Report: TAB REPORT
Function: Test, Adjust, & Balance
Date: 07/19/2023

06-26-23 CARMAX #7179 - MILWAUKEE, WI

Issue List

**RTU-9connected
08/31/2023**

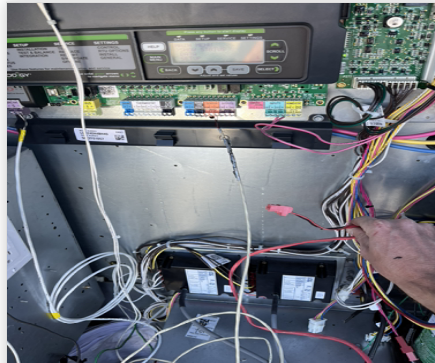
Issue Name : DI Smoke is not Landed in RTU-10
Description : DI Smoke input is not connected in RTU-10. Unsure of reason, left disconnected. Recommend service.
Created By : National TAB **Assigned To :** National TAB - Michael McDonnell
Status : Open
Originated Date : 08/31/2023 - Michael McDonnell - National TAB

PART PLAN – HVAC

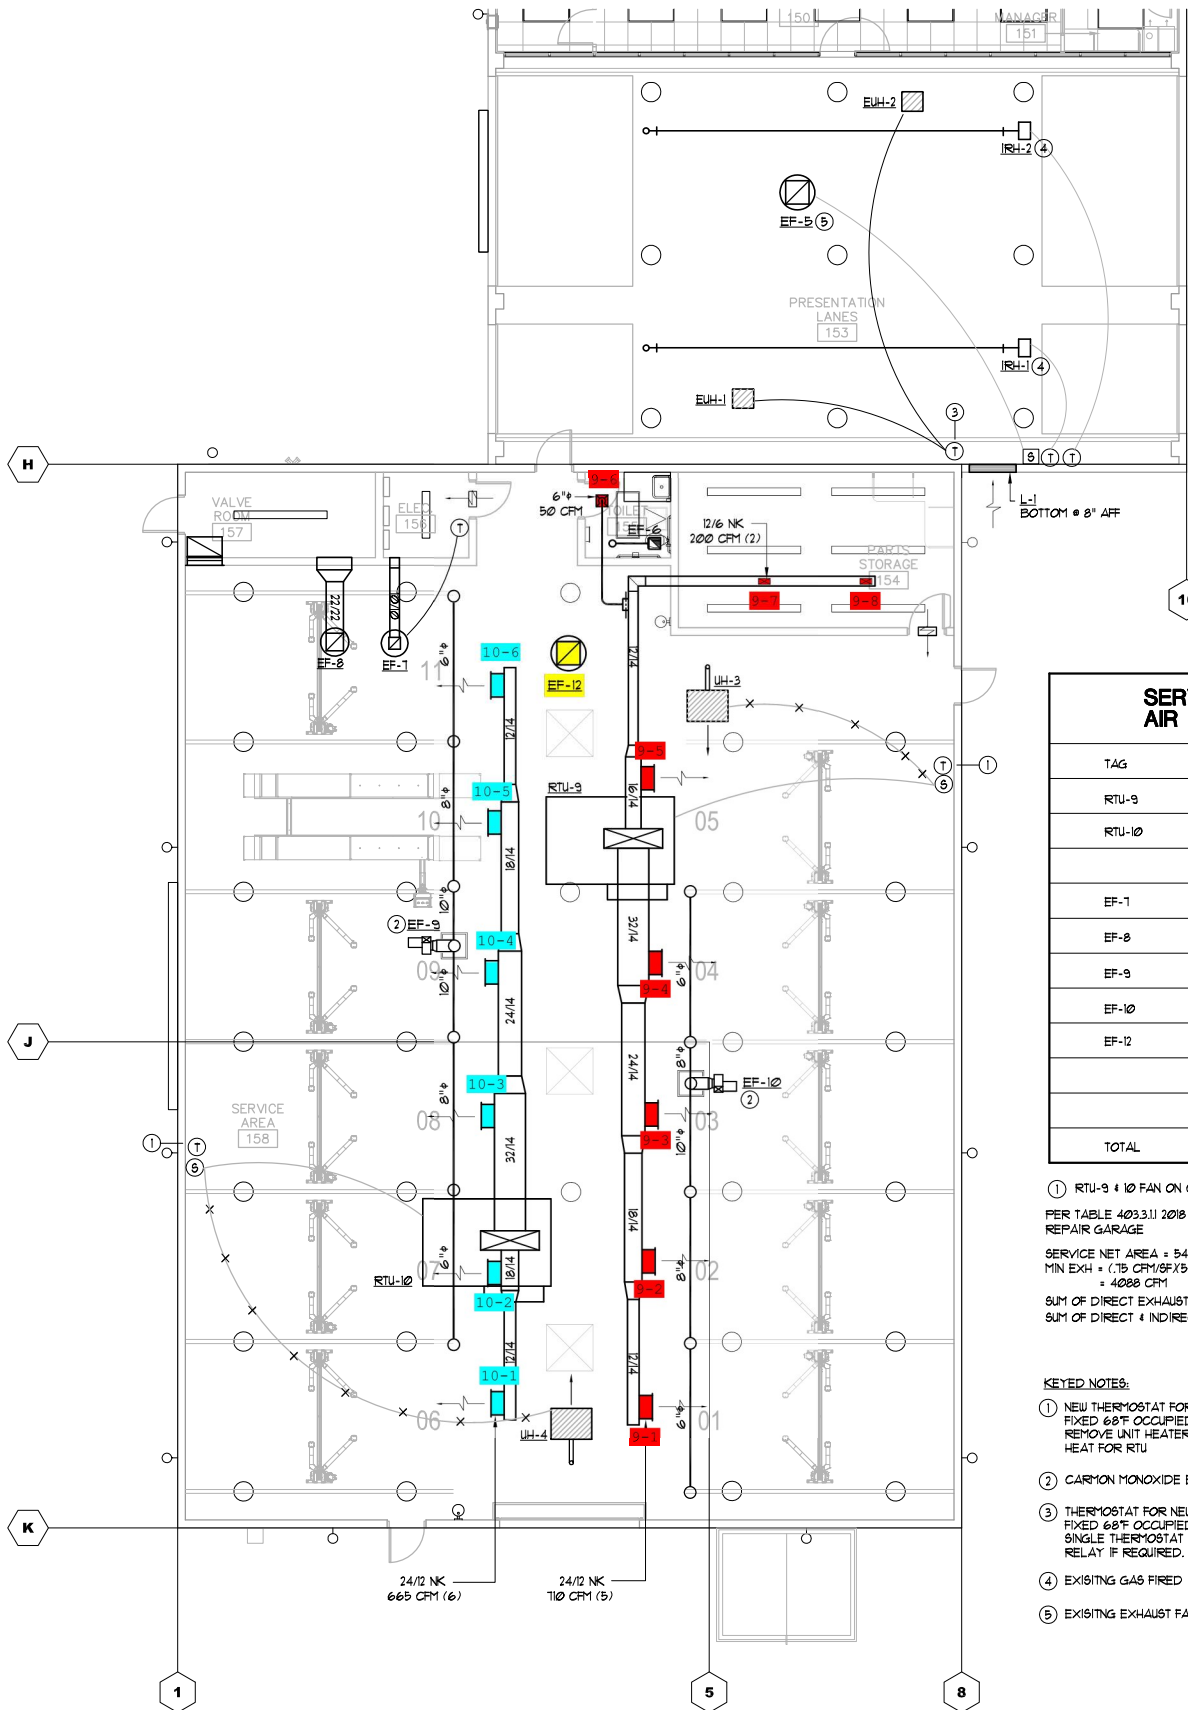
[1] UNABLE TO SLOW FAN TO DESIGN W/O SPEED CONTROL.
